PLANNING COMMISSION MEETING AGENDA

MAY 21, 2024

SUB: Meadow Brook Subdivision Phase 2

RZN/DCP: The Hamilton

Landscaping Plan

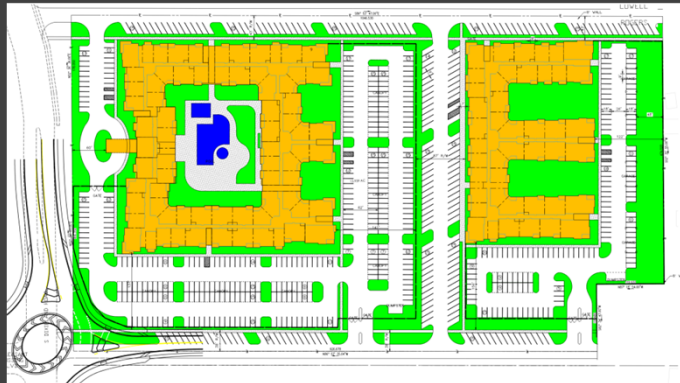
- Though the applicant is not proposing the U-NBT zoning buffer with the rezone request, they are providing the required transition standards that U-NBT calls for with the DCP.
- The applicant is proposing an 8' masonry wall where abutting existing single-family residential primarily along the eastern property line.
- They are also showing to meet the minimum 6' of bufferyard along abutting single-family residences to the east with evergreen trees planted.
- The residential transition height standards are being met as well. The closest structures to the adjacent single-family residences are the garages which are about 45' away from the property line.

Site Plan

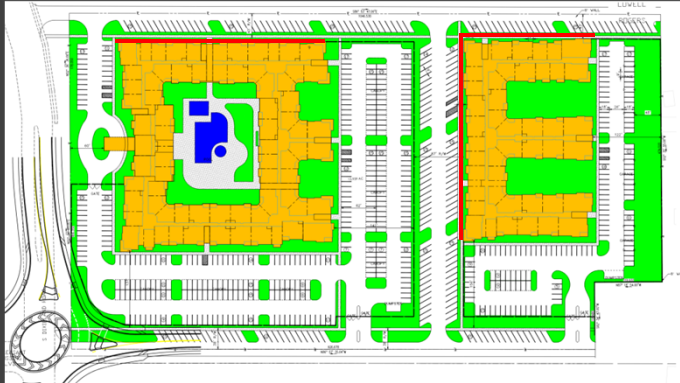
- The proposed use is allowed within the requested zoning designation.
- All but the following underlying R-MF zoning regulations are being met:
 - Front and exterior side setbacks along the proposed interior streets
 - Height requirements

Site Plan

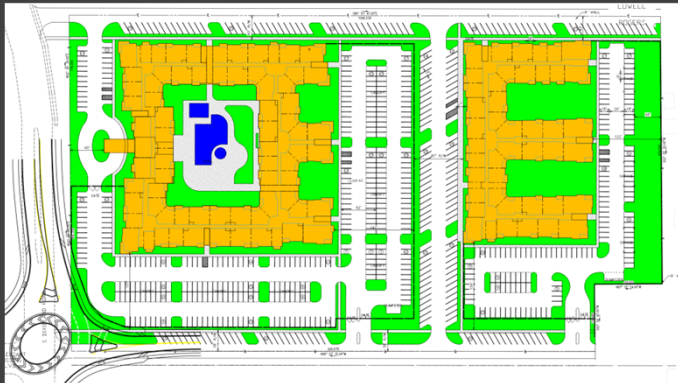
- The proposed building height is 59'10" (4 stories). The underlying zoning, R-MF, sets the max at 35'.

The maximum height allowed for the underlying R-MF zoning is 35'. The proposed building height is 59'10" (4 stories).
